Service Technical Information

MODEL NO.	AM-HX50 / HX55
SUBJECT	Noise heard on headphones during playback operation

REF.No. :G - A0 - 042 - E0

MAIN C.B. mechanism section

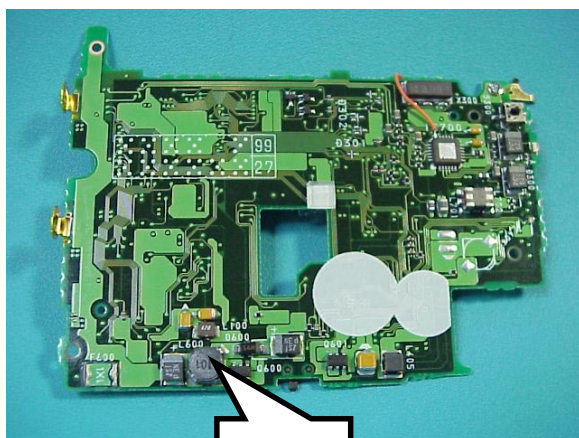
The models concerned may produce low-level noises with volume at minimum position.
The noises occur in synchronization with blinks of OPE LED, approximately 8 seconds after starting playback operation.
Take the following action against the problem.

Change the values from 100 μ H to 180 μ H on L600 in the power supply section.
